# MIL "ON" DTC P2111 and P0A0F After Cold Soak

YEAR(S)	MODEL(S)	ADDITIONAL INFORMATION
2011 – 2016	CT200H

**October 17, 2016 Rev2:**

Figure 1. Location of Authorized Modification Label for CT200h

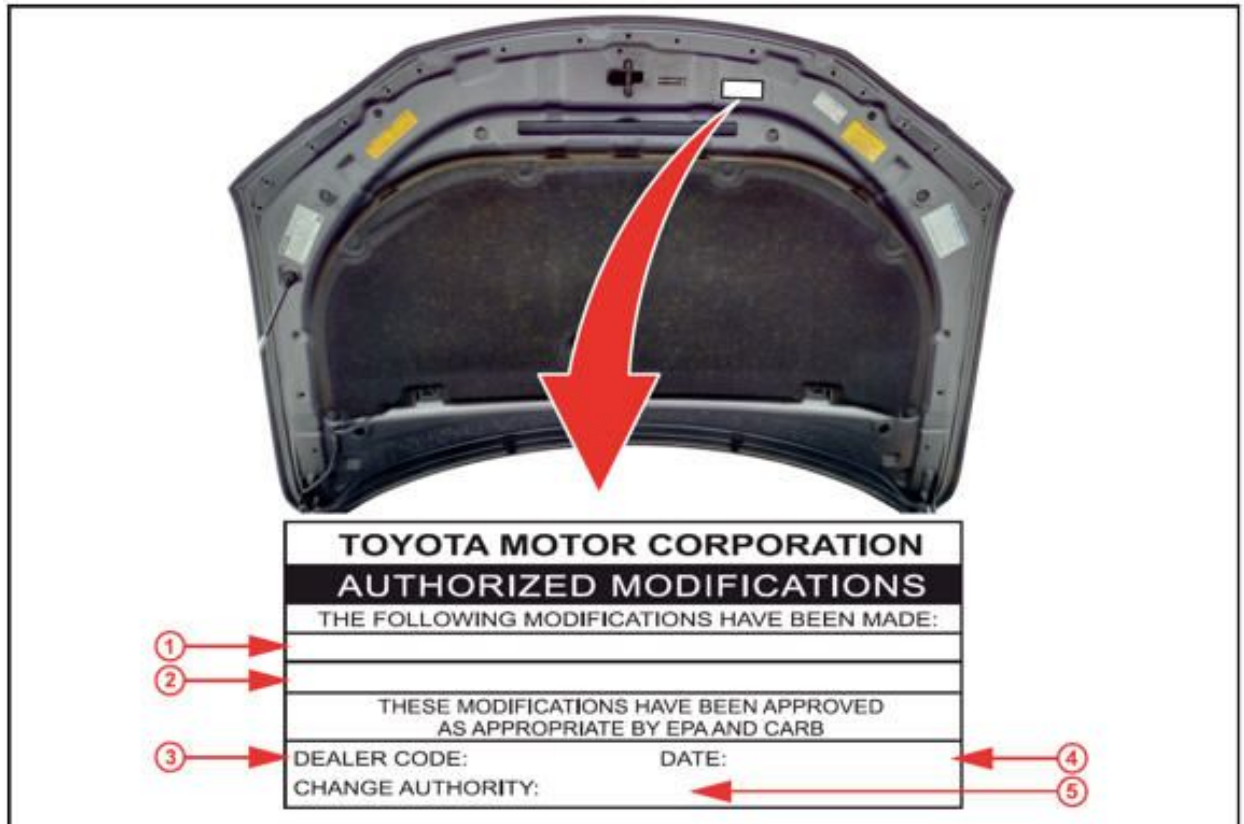
- Check for the Authorized Modifications Label affixed to the vehicle in the location shown in Figure 1 below.

5. Install the Authorized Modifications Label.
  - A. Using a permanent marker, enter the following information on the label:
    - ECM Part number (Refer to the Parts Information section for the NEW PART NUMBER)
    - Calibration ID(s) (Refer to the Calibration Information section for the NEW CALIBRATION ID)
    - Dealer Code
    - Repair Date
    - Change Authority (This bulletin number)
  - B. Affix the Authorized Modification Label to the vehicle at the location shown in Figure 1. The Authorized Modifications Label is available through the MDC, P/N 00451-00001-LBL.
6. Confirm the Repair.
  - A. Confirm P2111 and P0A0F are not present after cold soak.
  - B. Test Drive the vehicle to confirm proper vehicle operation.
